DEPARTMENT OF MECHANICAL,
AEROSPACE, AND NUCLEAR ENGINEERING

RCF 19-03
July 11, 2019

This letter requests a revision to the RPI Critical Experiments Facility, license CX-22, Technical Specifications.

Safety Evaluation of RCF Fence Line Reconfiguration
Glenn C Winters, RCF Operations Supervisor
November 2018

Figure 1: RCF Building Footprint and Exterior Fences

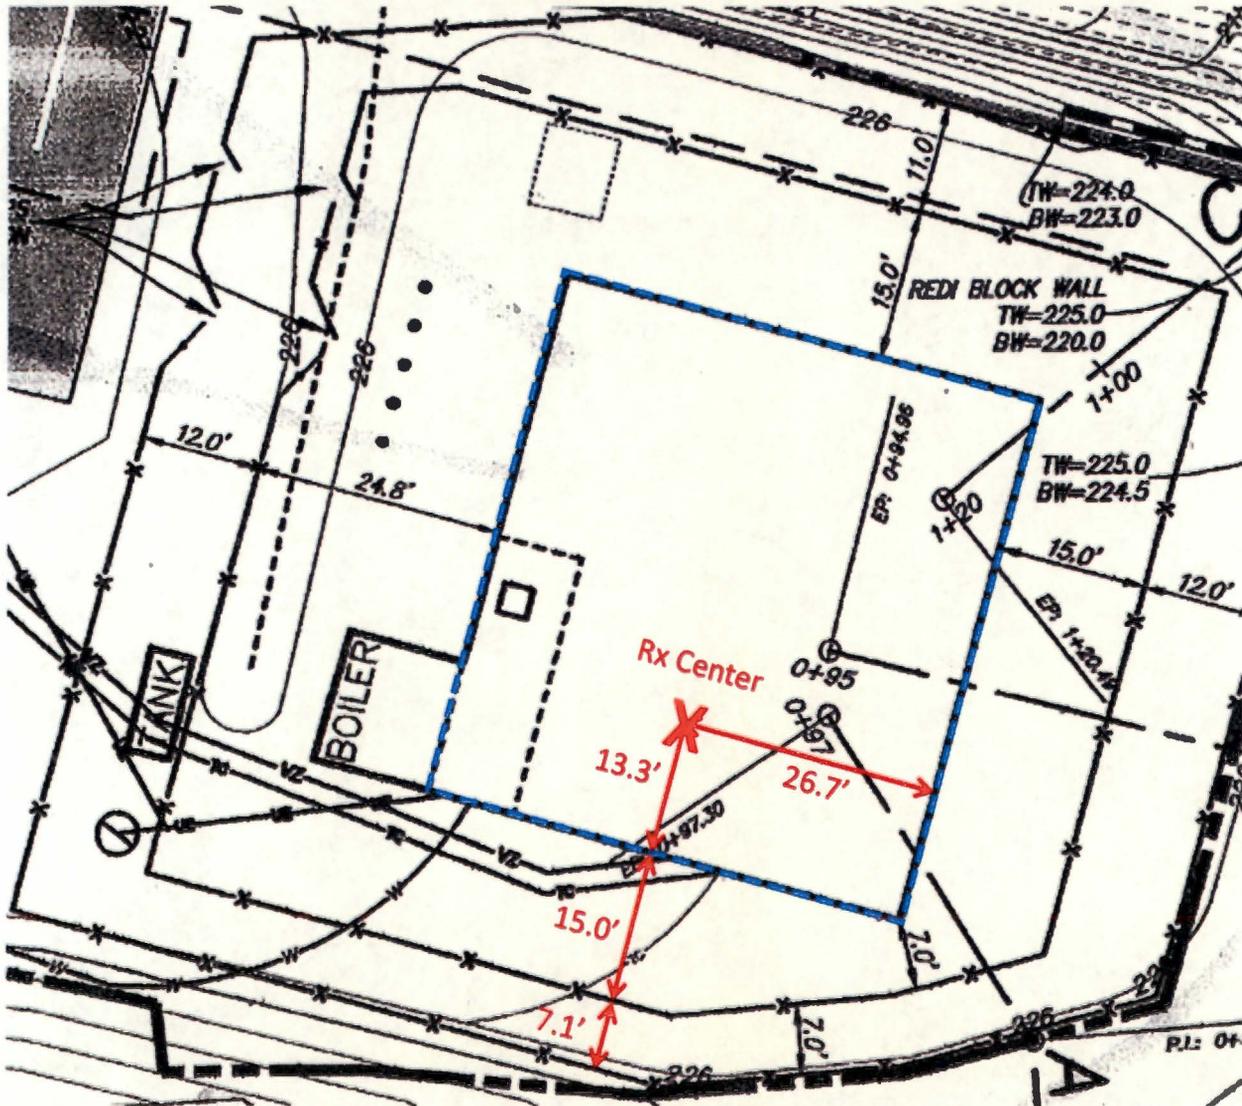
Figure 1 shows the construction drawing of the fence locations. North is up on the Figure. Based on the measurements in Table 1, the center of the reactor is identified relative to the South and East building exteriors. The measurements and Figure 1 show the bias. The reactor is closest to the southern fence boundary. The measurements also show that, in fact, the reactor is within an area with 30 feet radius, just not at the center of that area. Attachment 1 is a 10CFR50.59 evaluation made after the September inspection. The evaluation used the information from Table 1 above and concluded that a change to the RCF Technical Specification was appropriate to clarify the separation from the reactor provided by both fences.

Radiation levels were measured during the relicensing process at a reactor power of 13 watts and extrapolated to the 100 watt license limit. No locations on the outer fence exceeded the 2 mr/hr limit for exposure to the general public in 10CFR20. The shortest distance from the reactor to the fence for that measurement was 45 feet and the extrapolated dose rate was 1.15 mr/hr. The

exclusion area fence is now 35.4 feet from the center of the reactor. Assuming a $1/r^2$ relationship, the dose rate at that outer fence location would be 1.85 mr/hr, below the 2 mr/hr limit.

“An inner fence more than 28 feet from the center of the reactor defines the restricted area.
An outer fence more than 35 feet from the center of the reactor defines the exclusion area.”
